Application No. 10/568,800
Amendment dated June 9, 2009
Reply to Office Action of March 9, 2009

Docket No.: 66967-0008

AMENDMENTS TO THE DRAWINGS

Fig. 3b

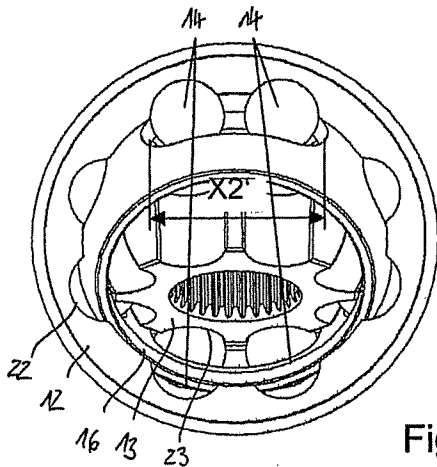
As an initial matter, the *Ouchi* reference fails to teach a twin ball joint, as expressly claimed by Applicants in claim 5. Indeed, Applicant's invention, as defined by independent claim 5, is "a constant velocity twin ball joint comprising: ... circumferentially adjoining pairs of tracks compris[ing] center lines of the outer and inner ball tracks which, when the first and second axes are aligned, are positioned in planes which extend parallel relative to one another and are symmetric relative to the first and second axes." As seen in FIGs. 3b or 3d below, a web is positioned between the balls 14 has a constant width over its length, thereby keeping the respective ball tracks parallel to each other.
